Determination 2025/003

Refusal to grant a building consent for the construction of a lift in an existing commercial building

R251 State Highway 2, Bethlehem, Tauranga

Figure 2: Proposed ground floor plan¹¹

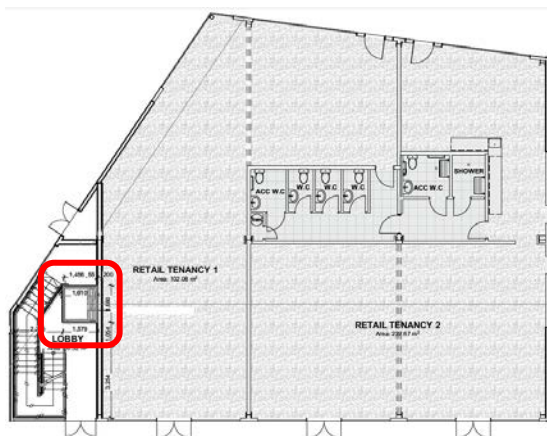
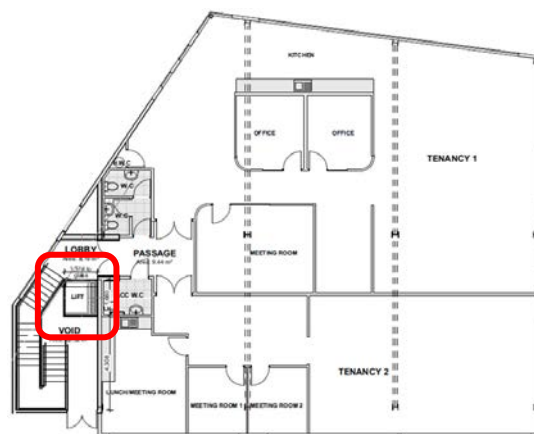
- 2.3. The new proprietary platform lift is to be constructed adjacent to the existing stair in a space between the ground floor entrance lobby and a first-floor landing (refer to figures 2 and 3)¹⁰.

¹¹ The location of the proposed new lift is marked by the ‘red’ squares.

- 4.24. The reasons given in the written notice include that an accessible lift is required under clause D1.3.4(c), and pursuant to section 118, the only acceptable solution for accessible lifts is NZS 4121. The authority is of the view the proposed lift does not comply with NZS 4121.

- 4.25. However, the authority is mistaken in its contention that section 118 refers to NZS 4121 (it is section 119(1)(a) that states NZS 4121 is an acceptable solution for requirements of people with disabilities), or that NZS 4121 is the only acceptable solution that can be used to establish compliance of the lift.

- 4.26. As previously discussed, clause D1.3.4(c) provides for a lift complying with clause D2, and pursuant to section 22, the Chief Executive has issued two acceptable solutions ie D2/AS1 and D2/AS2.²⁹ In this case the owner has chosen and relied on compliance with D2/AS2; consequently, the authority was required to assess the proposed building work against NZS 4334. As such, there were no grounds to refuse to grant the application for building consent based on an assessment of the proposed building work against NZS 4121.

- 4.27. Therefore, the reasons cited in the authority's written notice of 16 February 2024 do not constitute grounds for refusing to grant the application for building consent.

5.1. In accordance with section 188 of the Building Act 2004, I hereby reverse the decision by the authority to refuse to grant the application for building consent BC331285.
